UNITED STATES PATENT AND TRADEMARK OFFICE

APPLICATION NO.	FILING DATE	FIRST NAMED INVENTOR	ATTORNEY DOCKET NO.	CONFIRMATION NO.
10/047,534	01/15/2002	Brian A. Urbach	TRW(M)5857	4987
26294	7590	05/21/2004	EXAMINER	
TAROLLI, SUNDHEIM, COVELL & TUMMINO L.L.P. 526 SUPERIOR AVENUE, SUITE 1111 CLEVEVLAND, OH 44114			GARCIA, ERNESTO	
			ART UNIT	PAPER NUMBER
			3679

DETAILED ACTION

Fig. 3

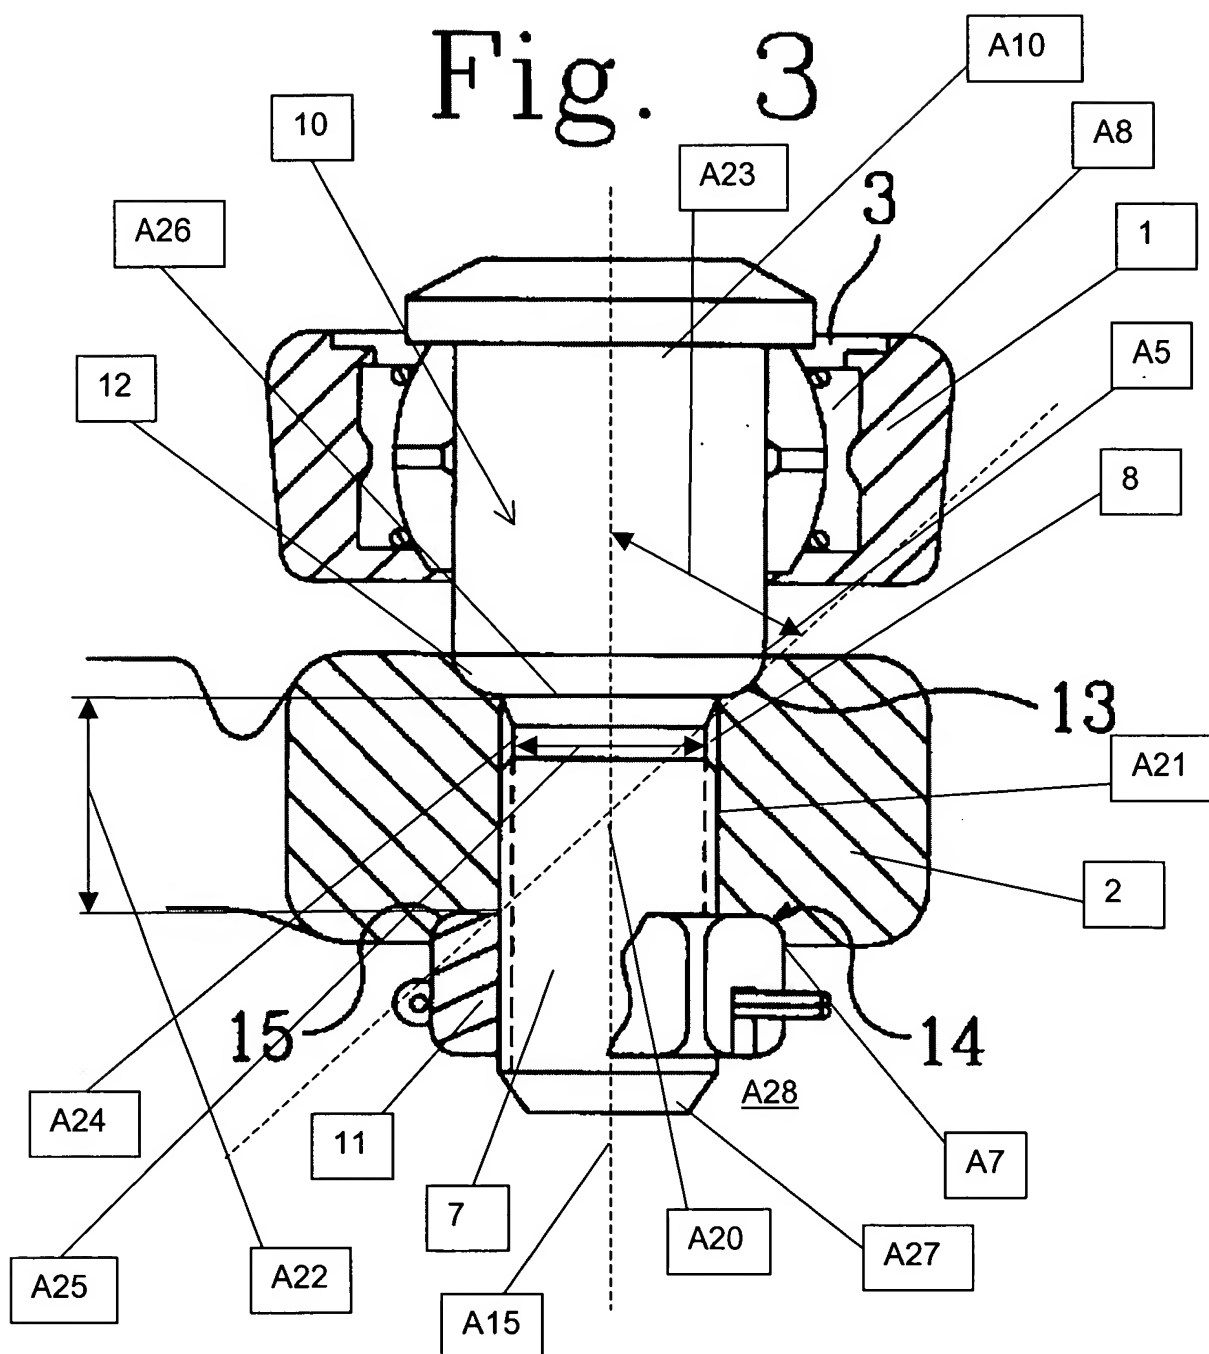
Regarding claim 1, Stroh discloses, in Figure 3, an apparatus comprising a first suspension member 1, a second suspension member 2, a socket A8, a one-piece stud 10, and a fastener 11. The second suspension member 2 has a through hole 8 with a first surface 13 and a second surface 15. The first surface 13 defines a first end A5 and the second surface 15 defines a second end A7 of the through hole 8. The first surface 13 and the second surface 15 converge toward a center A20 of the second suspension member 2. A cylindrical surface A21 is interposed between the first surface 13 and the second surface 15 and defines a central portion A22 of the through hole 8.

The socket A8 is connected with the first suspension member 1. The stud 10 has a first end portion A10 and a second end portion 7. The socket A8 supports the first end portion A10 in the socket A8. The second end portion 7 projects from the socket A8 and completely through the through hole 8. The second end portion 7 has a third surface 12 in engagement with the first surface 13. The fastener 11 is secured to the second end portion 7. The fastener 11 has a fourth surface 15 in engagement with

the second surface **15** of the second suspension member **2**. The second end portion **7** extends completely through the fastener **11**.

The socket **A8** and the stud **10** support the first suspension member **1**. The fastener **11** causes the first surface **13** and the third surface **12** to be pressed together, and the second surface **15** and the fourth surface **15** to be pressed together to secure the second suspension member **2** relative to the second end portion **7** of the stud **10**.

However, Stroh fails to disclose the first surface **13**, the second surface **15**, the third surface **12**, and the fourth surface **15** being frustoconical. Sommerer teaches, in Figure 2, a first surface **B1**, a second surface **B2**, a third surface **B3**, and a fourth surface **B4** being frustoconical. Sommerer does not explicitly explain why the surfaces are frustoconical. It appears that frustoconical surfaces are an alternative configuration for mating and aligning parts together. Applicant is urged to view Greubel et al. for support of choosing the surface to be spherical or frustoconical (col. 3, line 61 - col. 4, line 10). Therefore, as taught by Sommerer and Greubel et al., it would have been obvious to one of ordinary skill in the art at the time the invention was made to make the surfaces frustoconical to mate and align parts together.

Regarding claim 2, as modified above, the stud **10** has a longitudinal central axis **A15** on which the third surface **12** is centered. The third surface **12** of the stud **10** extends at a first angle **A23** to the central axis **A15**. The first surface **13** and the second

surface **15** of the second suspension member **2** extend at the first angle **A23** relative to the central axis **A15**.

Regarding claim 3, the fourth surface **15** on the fastener **11** extends at the first angle **A23** relative to the central axis **A15** when the fastener **11** is secured to the second end portion **7** of the stud **10**.

Regarding claim 4, the third surface **12** extends at a 45-degree angle to the central axis **A15**. Applicant is reminded that the third surface **12** extends from 0 to 90 degrees and 45 degrees is one of the angles in between.

Regarding claim 5, the fastener **11** is a nut and the second end portion **7** of the stud **10** has a threaded end portion (col. 2, lines 47-49).

Regarding claims 6 and 8, the second end portion **7** of the stud **10** has a cylindrical portion **A24** extending from the third surface **12** of the stud **10** in a direction away from the first end portion **A10** of the stud **10**. The cylindrical portion **A24** has a diameter **A25** smaller than a smallest diameter **A26** of the third surface **12** of the stud **10**. The cylindrical portion **A24** of the second end portion **7** of the stud **10** is spaced away from and extends parallel to the cylindrical surface **A21** of the second suspension member **2** when the cylindrical surface **A21** is in abutting engagement with the first surface **13**.

Regarding claim 7, the stud **10** has a longitudinal central axis **A15** on which the third surface **12** is centered. The third surface **12** of the stud **10** extends at a first angle **A23** to the central axis **A15**. The first surface **13** and the second surface **15** of the second suspension member **2** extend at the first angle **A23** relative to the central axis **A15**. The fourth surface **15** extends at the first angle **A23** to the central axis **A15** when the fastener **11** is secured to the second end portion **7** of the stud **10**. The fastener **11** is a nut and the second end portion **7** of the stud **10** has a threaded end portion (col. 2, lines 47-49).

Regarding claim 10, as modified above, the first surface **13** and the cylindrical surface **A21** converge with one another in the through hole **8** the second suspension member **2**. The second surface **15** and the cylindrical surface **A21** converge with one another in the through hole **8** in the second suspension member **2**.

Regarding claim 11, as modified above, the cylindrical surface **A21** extends from the first surface **15** to the second surface **15** so that the first surface **13**, the second surface **15** and the cylindrical surface **A21** entirely form the through hole **8** in the second suspension member **2**.

Regarding claim 9, Stroh, as discussed above, discloses the second end portion 7 of the stud 10 includes a terminal end **A27**. The terminal end **A27** is located on a side **A28** of the fastener 11 opposite the first end portion **A10** when the fastener 11 is secured to the second end portion 7 of the stud 10. However, Stroh fails to disclose the terminal end **A27** having a hexagonal configuration. Pazdirek et al. teach in Figure 2 a terminal end having a hexagonal configuration (see Fig. 1 from the top view). Pazdirek et al. do not elaborate on this feature. It appears however, that the hexagonal configuration prevents the stud from being rotated in a through hole when a fastener is fastened to a threaded portion of the stud. Therefore, as taught by Pazdirek et al., it would have been obvious to one of ordinary skill in the art at the time the invention was made to make the terminal end have the hexagonal configuration to prevent the stud from slipping in the through hole when the fastener is fastened to the stud.
